**AMENDMENT #1
DURHAM YORK ENERGY CENTRE**

**Design and Operations Report
in Support of Environmental
Protection Act Section 27
Certificate of Approval (Waste)
Application**

Report Number: 10-1151-0343 (5000)- Amendment # 1

PROJECT	DURHAM YORK ENERGY CENTRE		
TITLE	PRELIMINARY TIPPING FLOOR LAYOUT		
 Mississauga, Ontario	PROJECT NO.	10-1151-0343	SCALE AS SHOWN
	DESIGN	PRM	25 Aug. 2010
	GIS	PRM	24 May. 2011
	CHECK	PN	24 May. 2011
	REVIEW	AC	24 May. 2011
			FIGURE: 13

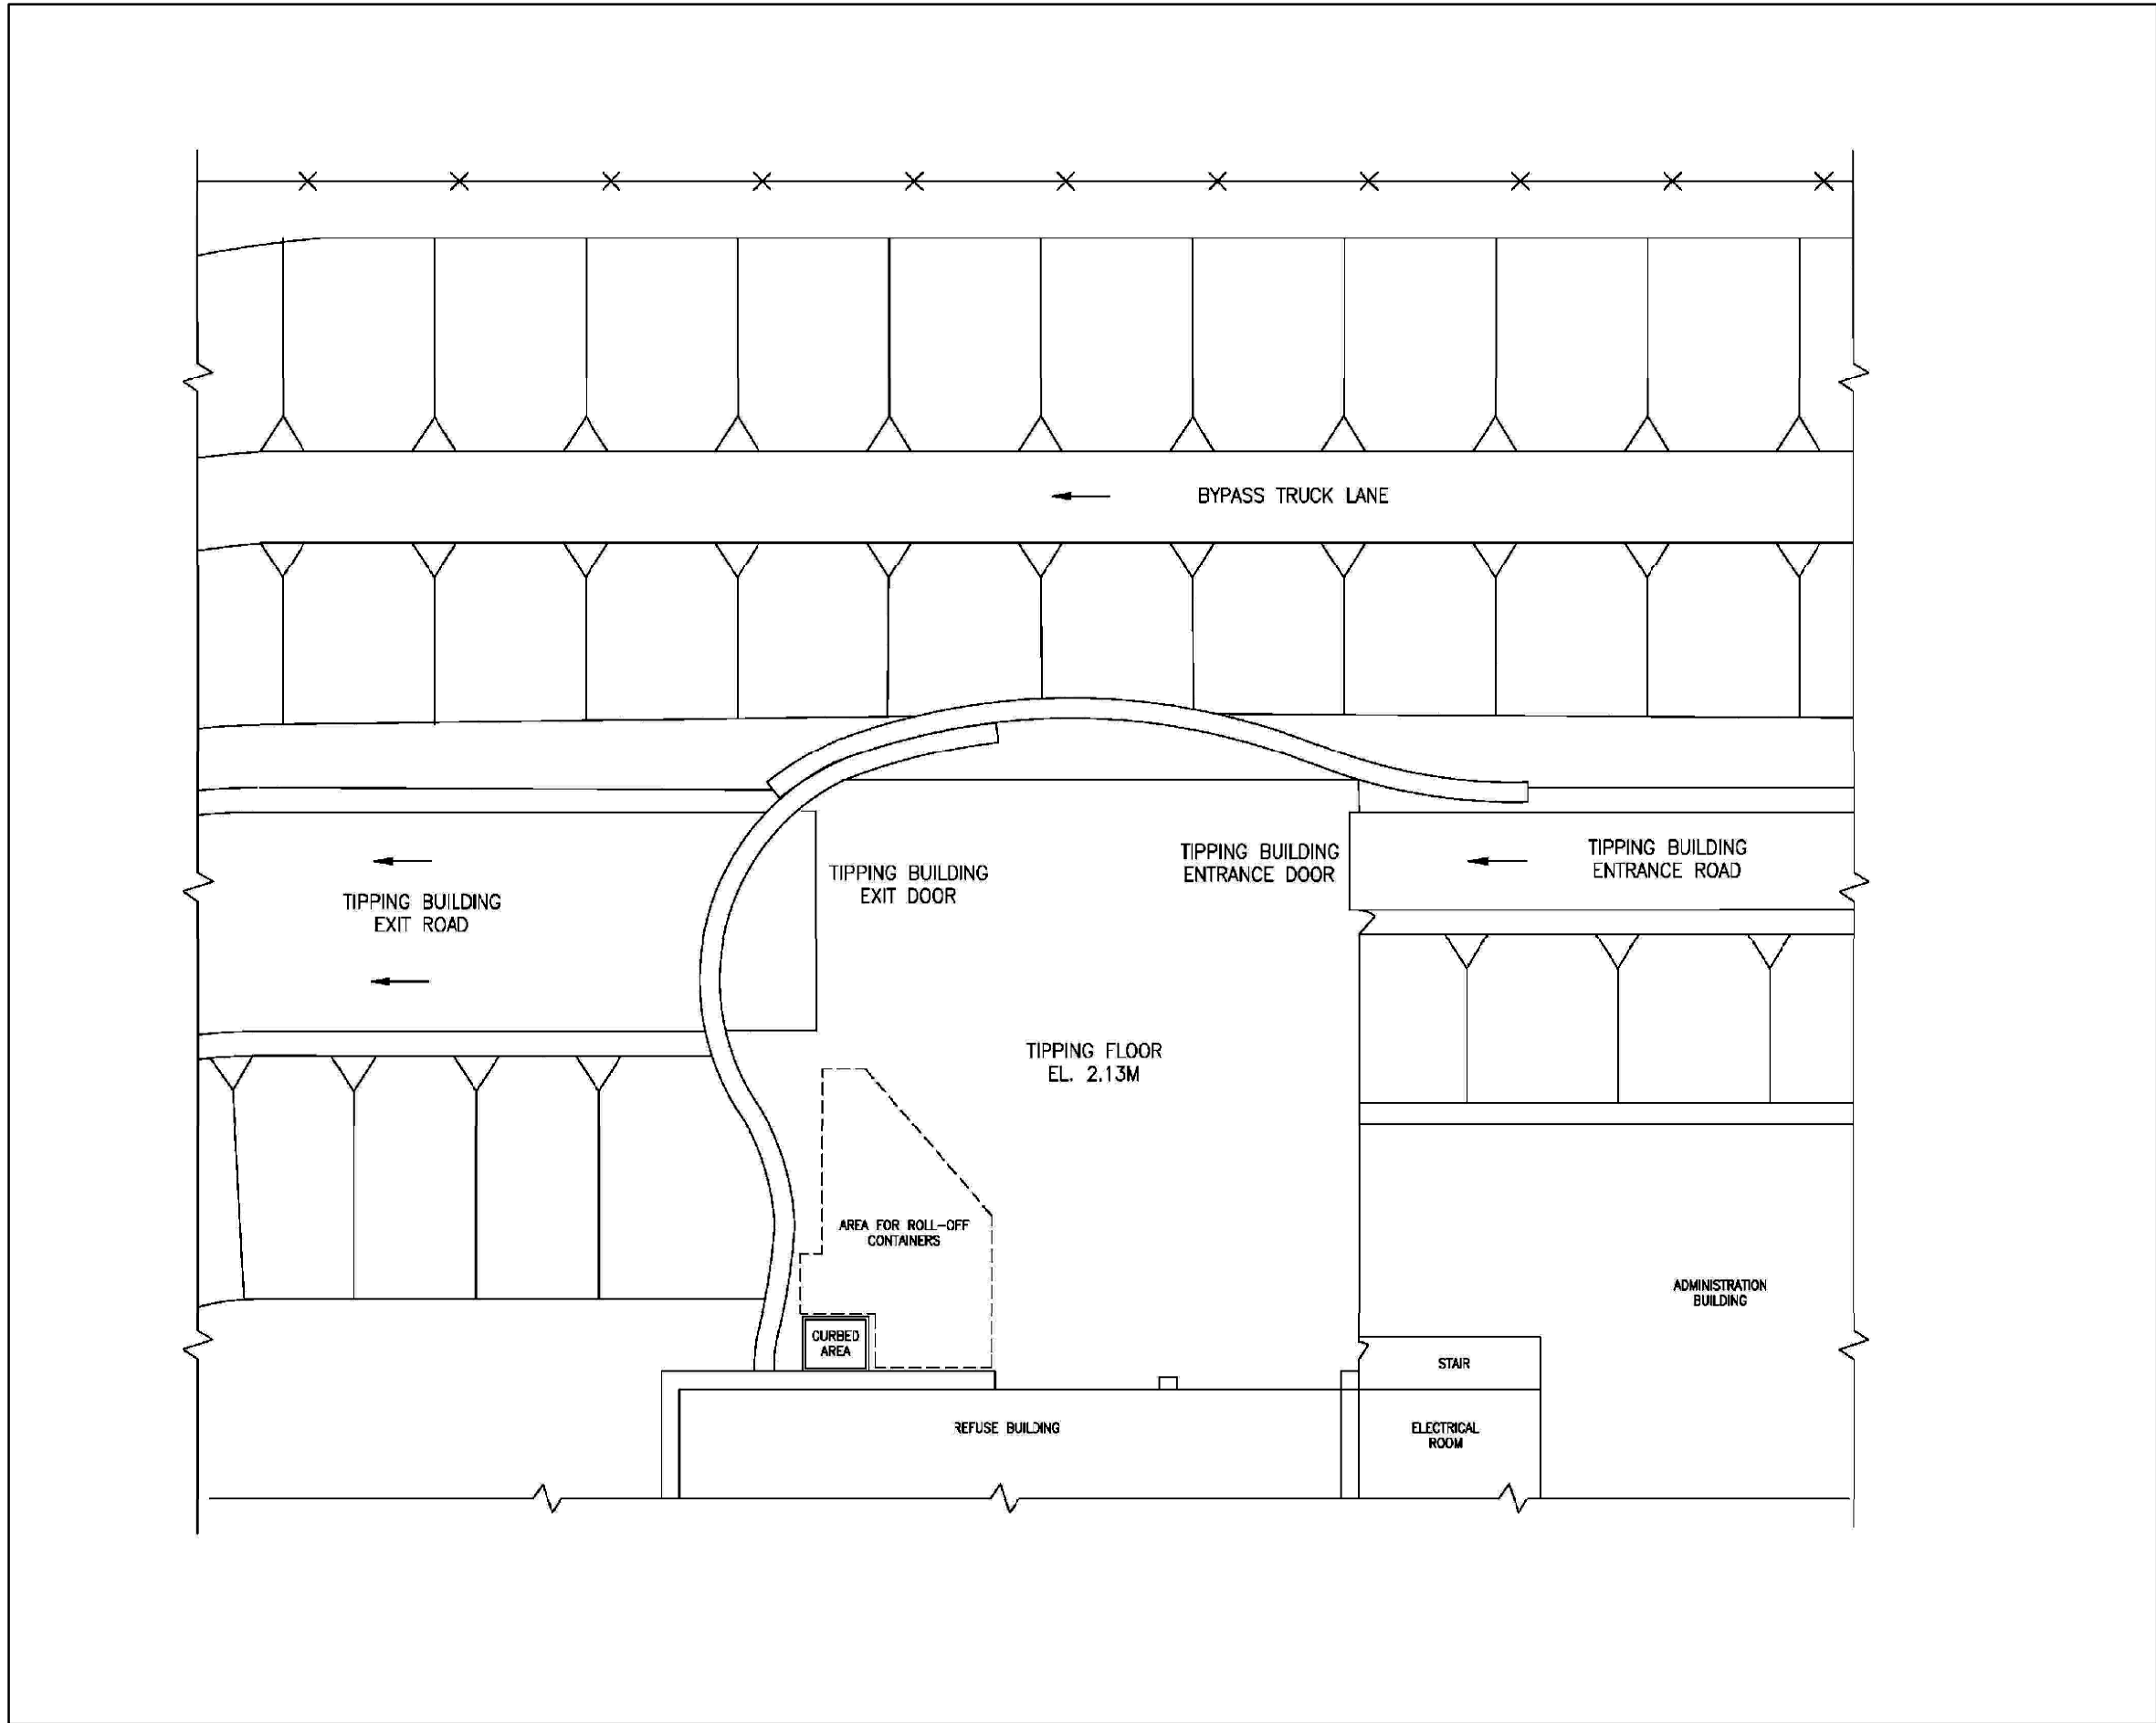
“Incoming non-hazardous unacceptable waste will either be stored in two roll-off bins (maximum 30m³ each) located on the tipping floor (Refer to Figure 13 Rev 1 for estimated bin location) or stored in the appropriate bunker in the Residue Building. The appropriate bunker (residue, non-ferrous metal or ferrous metal bunker) will be determined by the nature of the waste upon visual inspection by facility staff. If tipping hall containers are utilized, containers will be removed and replaced when the container is full. If non-hazardous unacceptable waste is stored in the Residue Building, it will be loaded with the associated residue or metals into a covered trailer on a regular basis and will be sent to a licensed landfill in New York State, or an alternative approved disposal facility. Please also refer to Appendix D on SOPs pertaining to the handling of unacceptable waste.”

“ A 2.5m x 3m curbed area will be located on the south-west side of the tipping hall (see Figure 13) for temporary storage of unacceptable waste. The curbed area is a circumferentially curbed, impervious, reinforce concrete area, and it will not have drains.”

PROJECT	DURHAM YORK ENERGY CENTRE		
TITLE	TYPICAL GRIZZLY BUILDING LAYOUT		
 Golder Associates Mississauga, Ontario	PROJECT NO.	10-1151-0343	SCALE AS SHOWN
	DESIGN	PRM	25 Aug. 2010
	GIS	PRM	24 May. 2011
	CHECK	PN	24 May. 2011
	REVIEW	AC	24 May. 2011
			FIGURE: 21

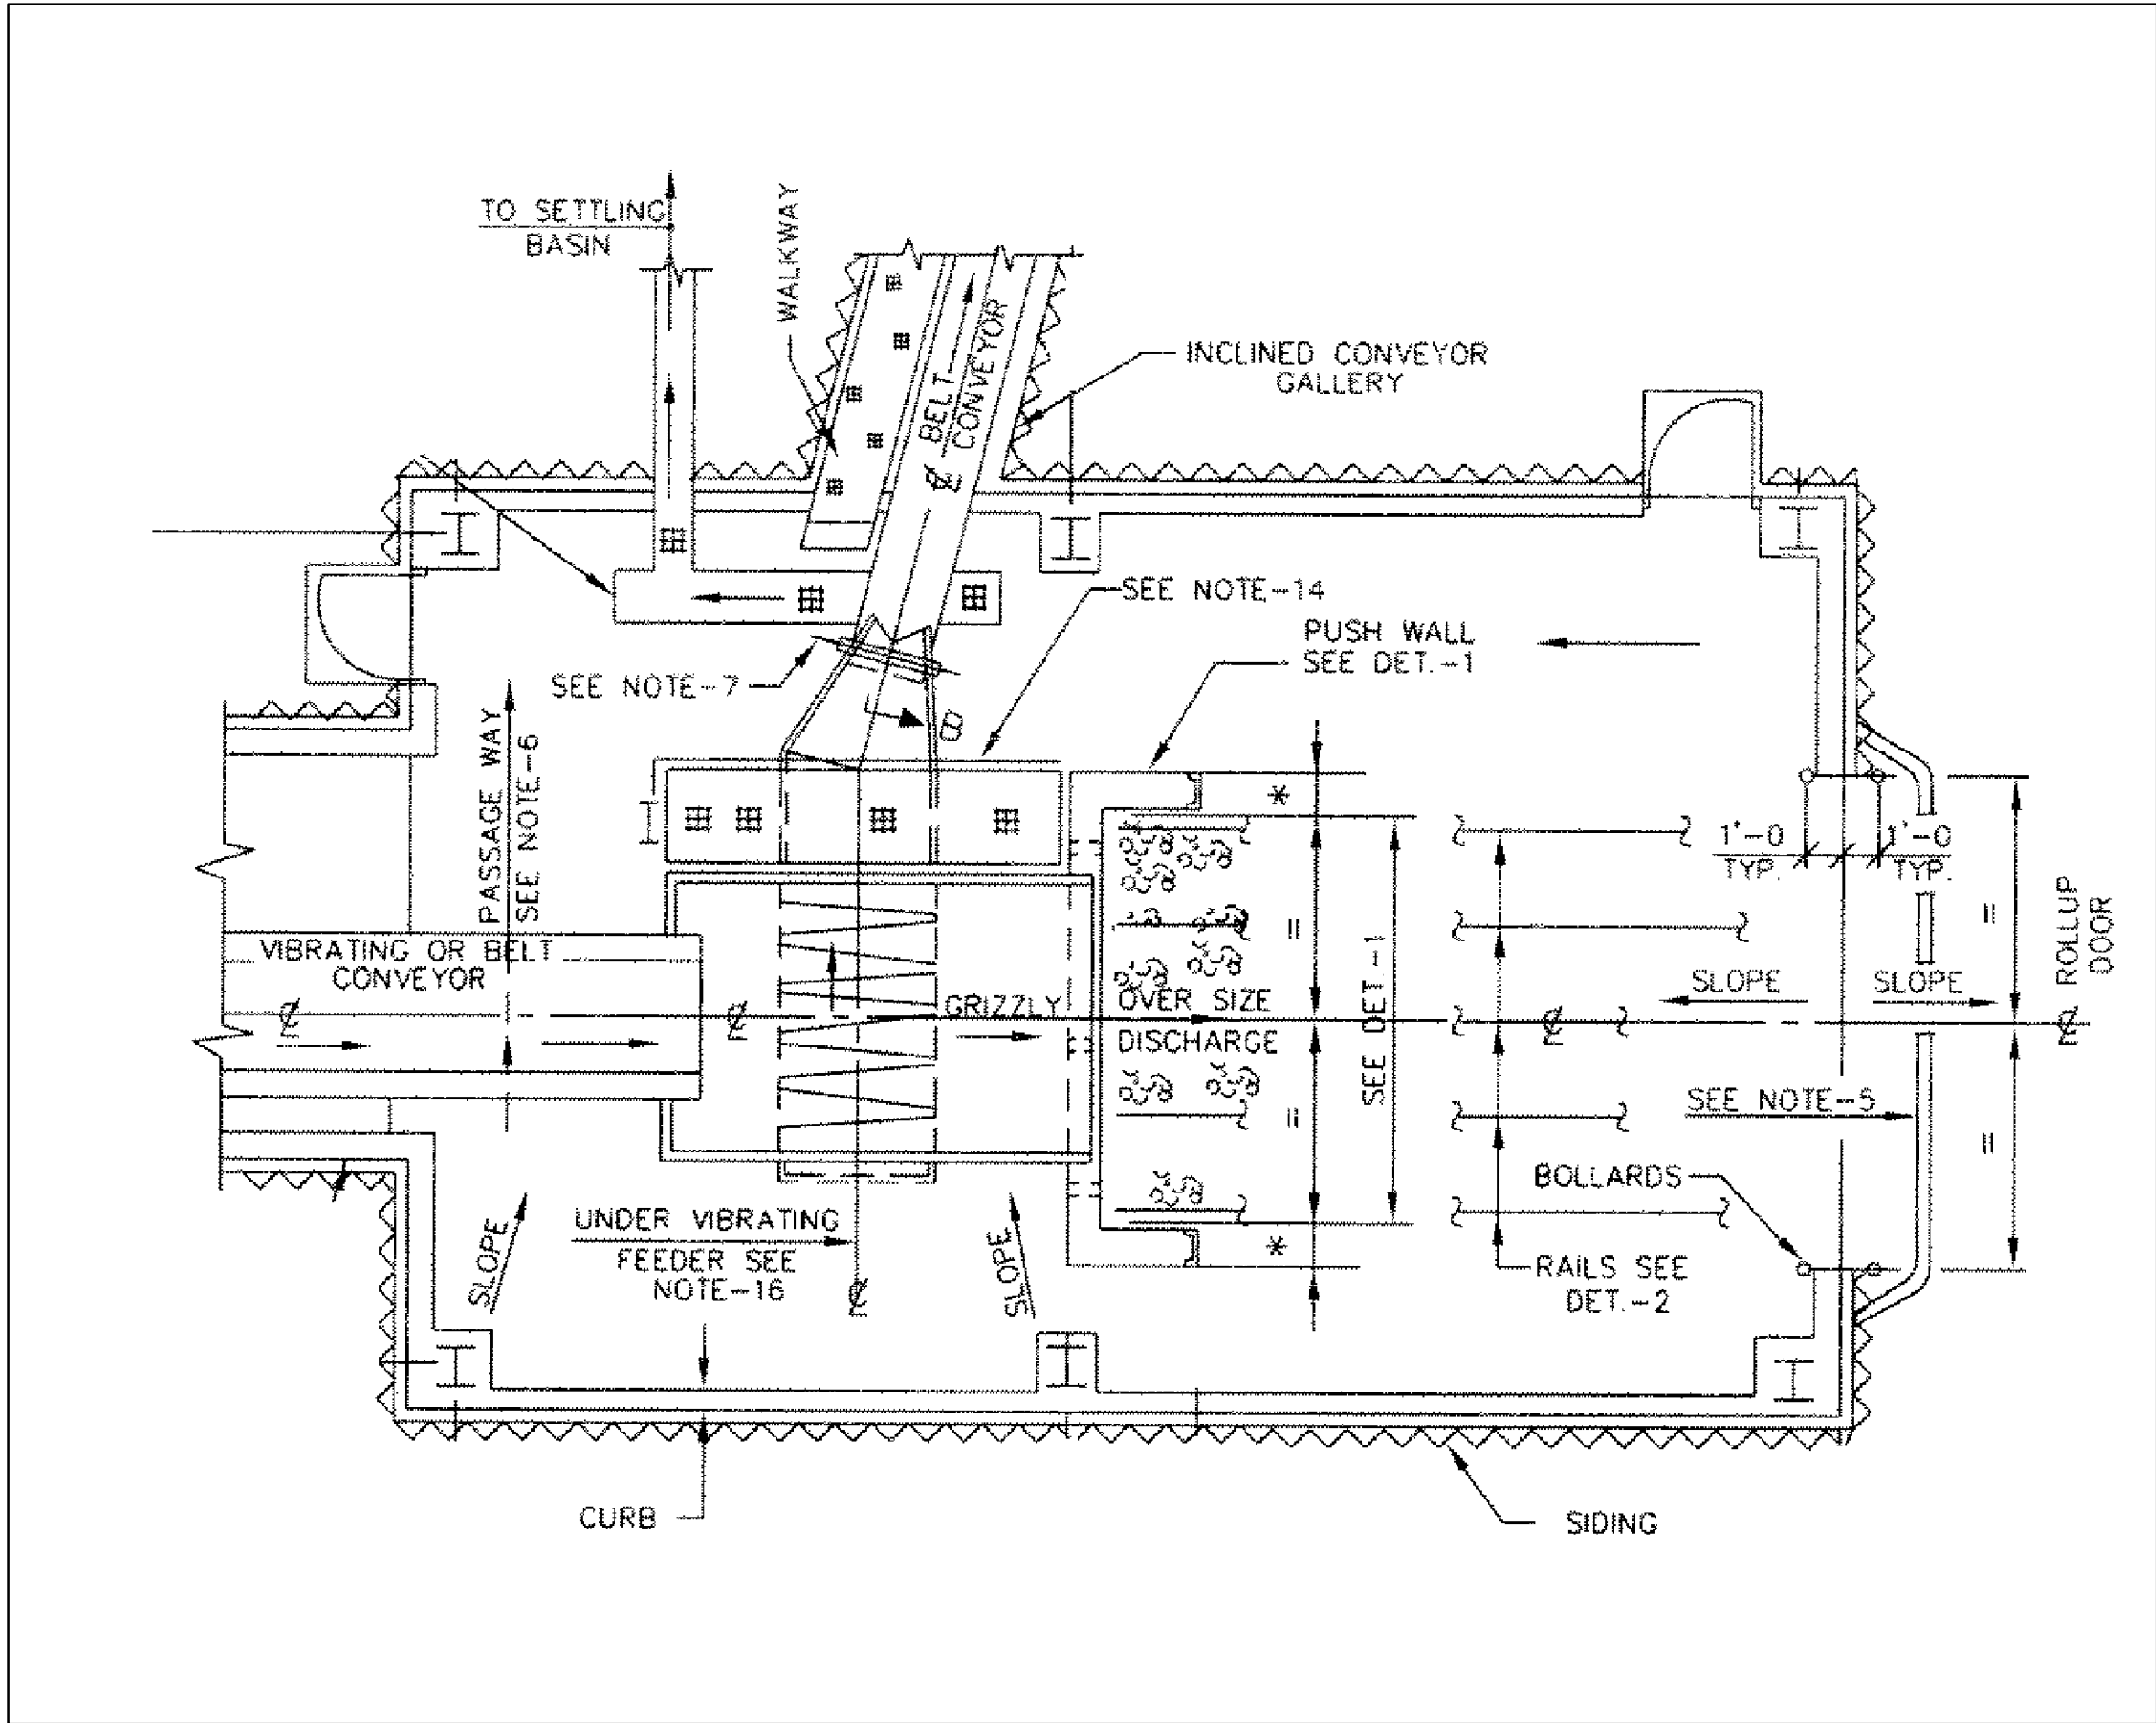
“The grizzly scalper is a heavy duty screen for separation of large objects (approx. 200mm or greater) in the bottom ash stream. Large objects are taken out of the stream to increase metals recovery percentages and prevent damage to upstream equipment. After being separated by the grizzly, the large objects fall to the floor in front of a pushwall at the base of the grizzly. The objects are then scooped up using a front end loader and transported to the Residue Building. The overs will be visually inspected to determine the material type and deposited in the appropriate bunker (residue, ferrous or non-ferrous) with the balance of the respective material. The overs are part of the residue or metals recovery stream and will be transported to the proper disposal facility with the balance of the respective material. Please refer to Figure 21 for a typical Grizzly Building layout. The Grizzly Building proposed for the Facility will be laid out similarly. Please also refer to Figures 17 and 18 of the Application for the residue and metals storage bunker layout.”
